**PALMAR ELITE 600**

SCALE: N/A  
DATE: 11/28/90  
DESIGN BY:  
AMP SCHEMATIC  
DRAWING NO:

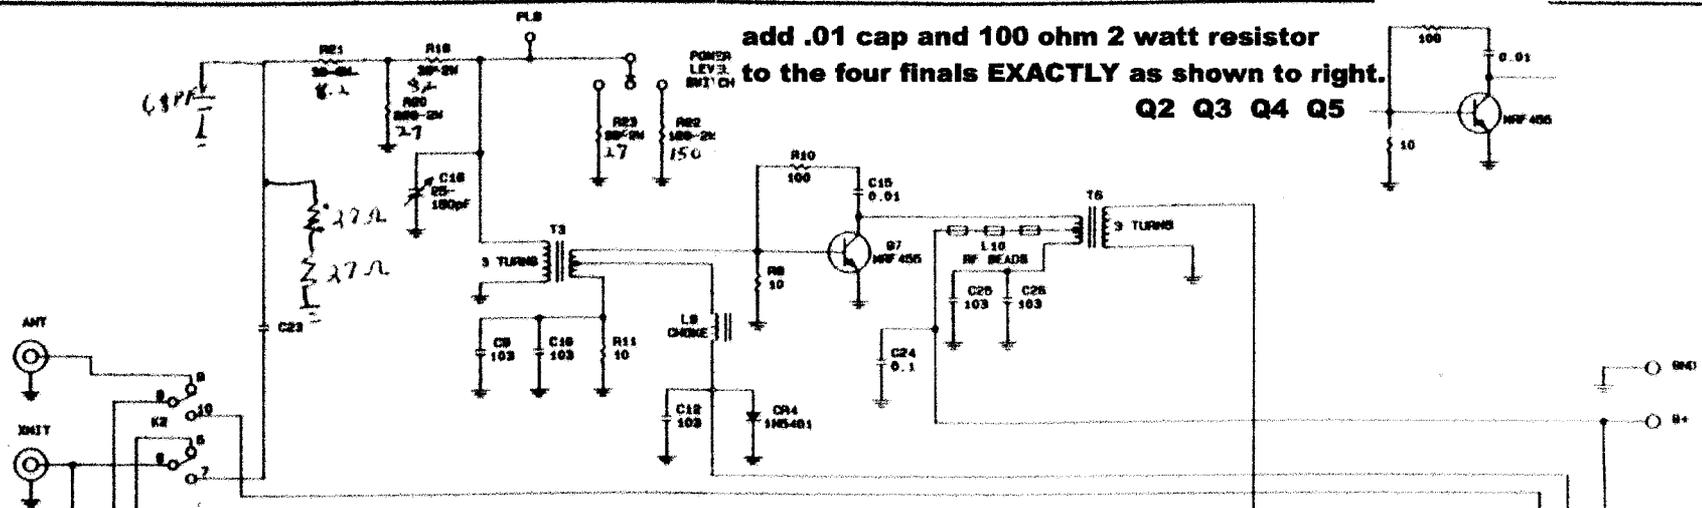
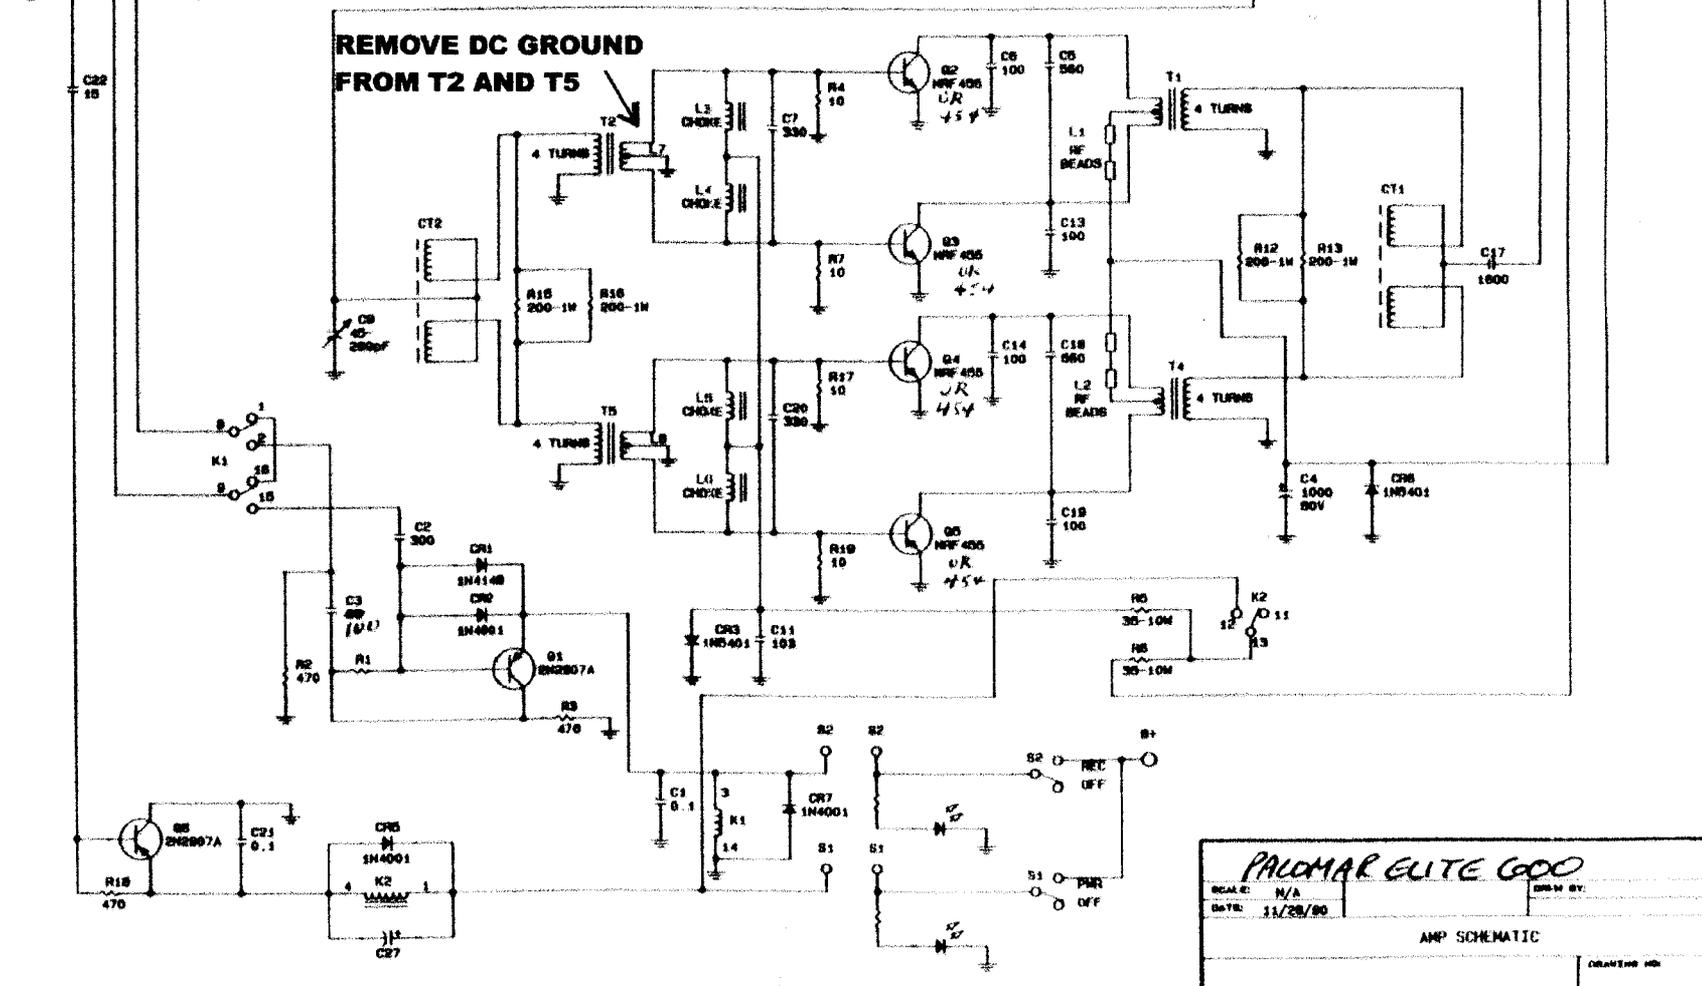
add .01 cap and 100 ohm 2 watt resistor  
to the four finals EXACTLY as shown to right.

**REMOVE DC GROUND FROM T2 AND T5**
